Haweswater Aqueduct Resilience Programme - Proposed Bowland Section

Supplementary Environmental Information Report

Project No: B27070CT
Document Title: Proposed Bowland Section
Supplementary Environmental Information Report
Document Ref.: LCC_RVBC-BO_SEI
Revision: 0
Date: February 2022
Client Name: United Utilities Water Ltd

FIGURE 6.5

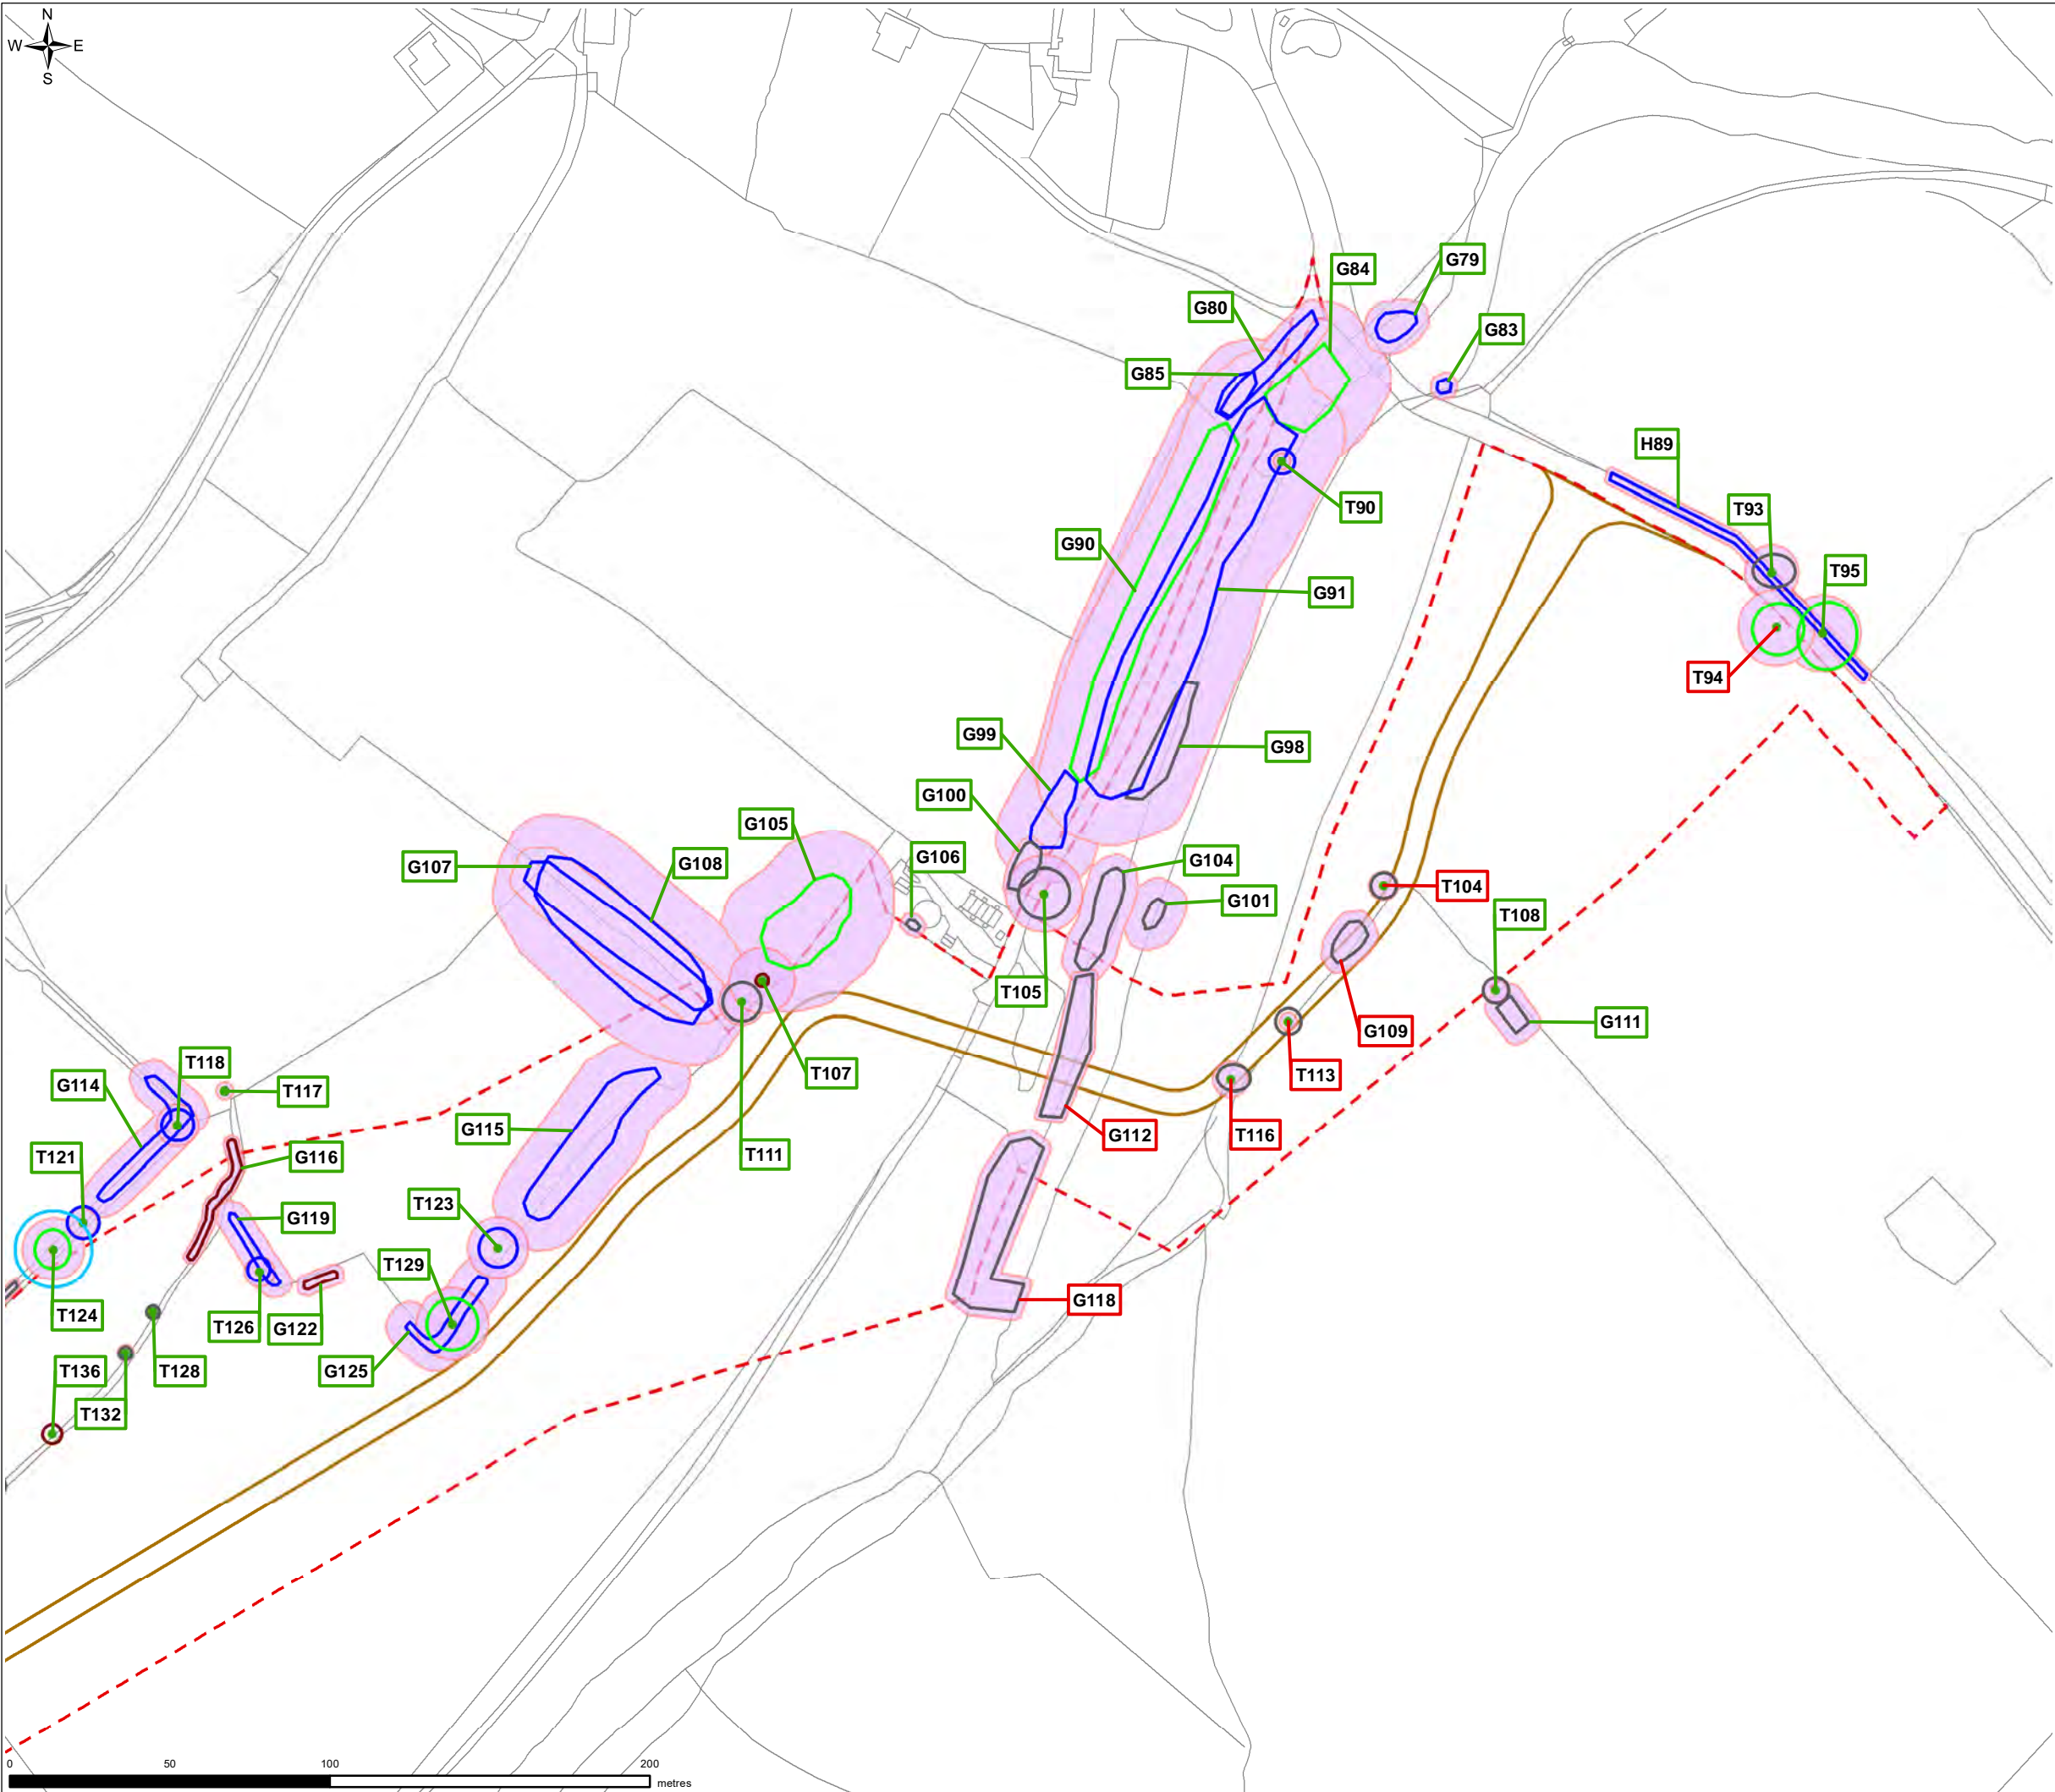
- 49) The updated associated Tree Constraints and Assessment Plans (LCC_RVBC-BO-FIG-006-005-AD1) contain information on tree feature locations and their RAG assessment impacts. The update to the Preliminary Trees at Risk Plan (LCC_RVBC-BO-FIG-006-006) shows the extent of potential tree loss, trees at risk and tree retention within the planning application boundary.
